**Town of Surfside  
SPECIAL PLANNING & ZONING BOARD  
AGENDA**

**AUGUST 5, 2021 – 6:00 p.m.**

**To:** Planning and Zoning Board  
**Thru:** Andrew Hyatt, Town Manager  
**From:** Walter Keller, PE, AICP., Town Consultant Planner  
Marlin Engineering, Inc.  
**CC:** Jason Greene, Assistant Town Manager  
Lillian Arango, Town Attorney  
James McGuinness, Town Building Official  
**Date:** June 14, 2021  
**RE:** 500 93<sup>rd</sup> Street – New 2 Story Single Family Residence

**To:** Planning and Zoning Board  
**Thru:** Andrew Hyatt, Town Manager  
**From:** Walter Keller, PE, AICP., Town Consultant Planner  
Marlin Engineering, Inc.  
**CC:** Jason Greene, Assistant Town Manager  
Lillian Arango, Town Attorney  
James McGuinness, Town Building Official  
**Date** August 5 2021  
**RE:** 9234 Bay Drive – New 2 Story Single Family Residence

A-201  
 FIRST FLOOR  
 PLAN  
 SHEET NO. 4 OF 8

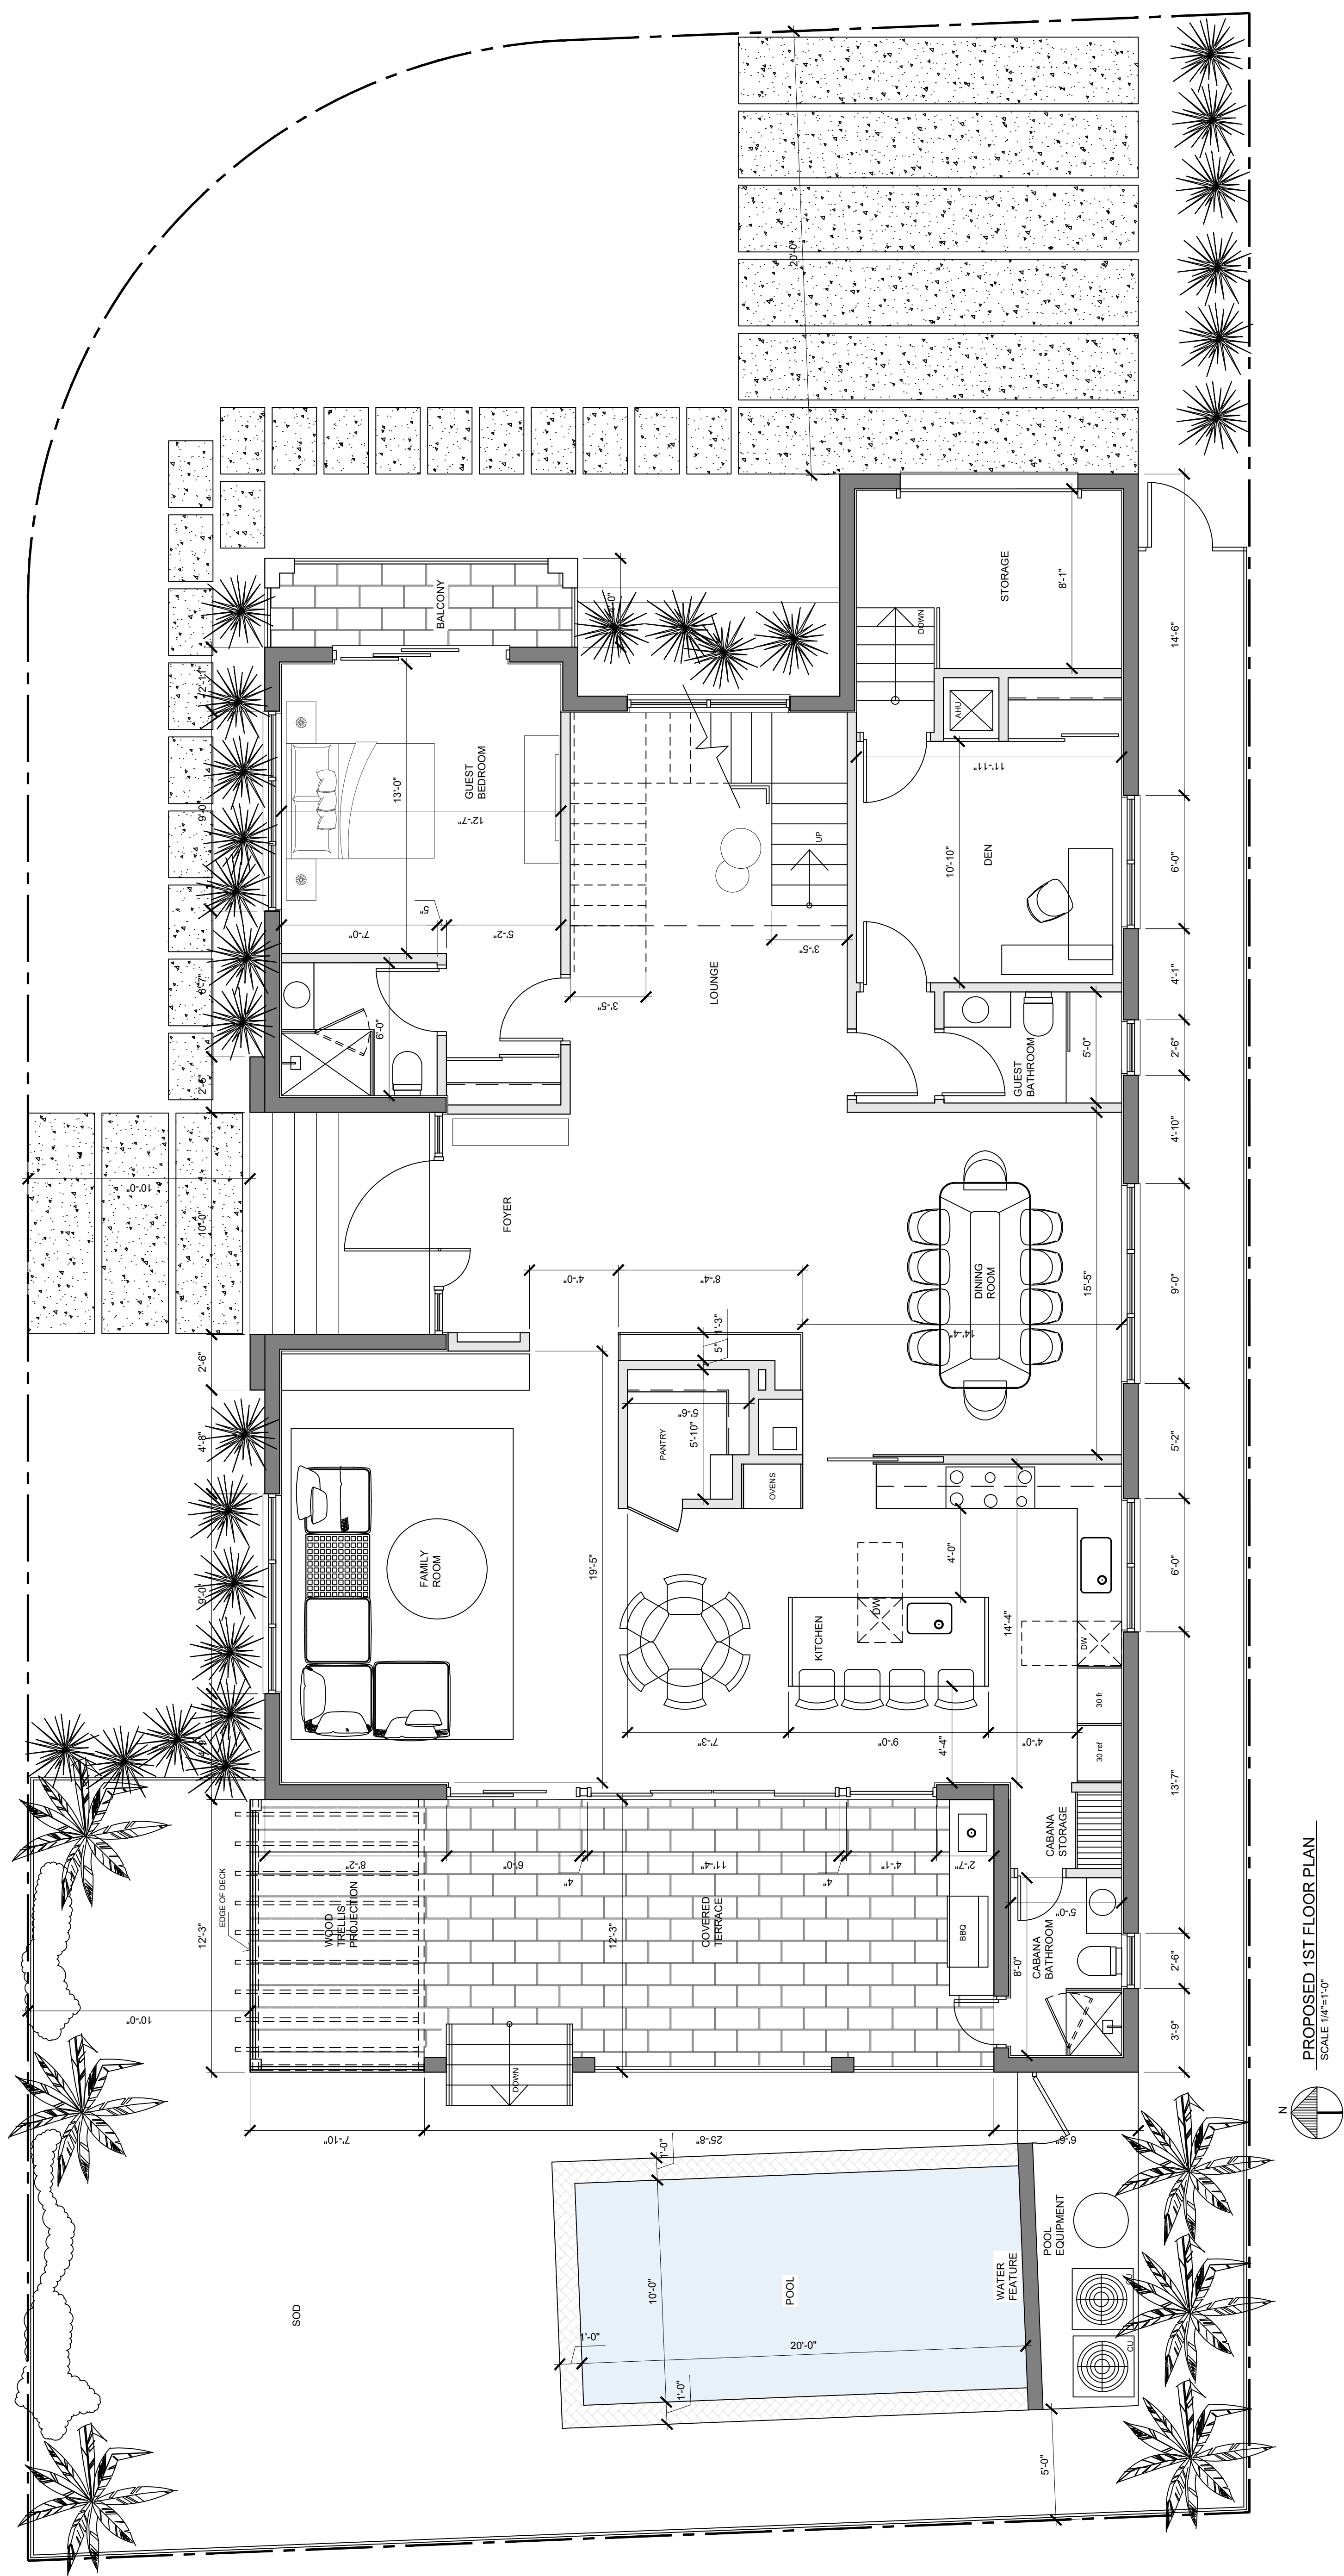
Provide a height dimension for the trellis. Maximum trellis height is limited to 12 feet.

Street trees area are required along the public street frontage of the property. At least 2 trees are required on Byron Avenue and four on 93<sup>RD</sup> Street. It is suggested the tress be planted along the property lines.
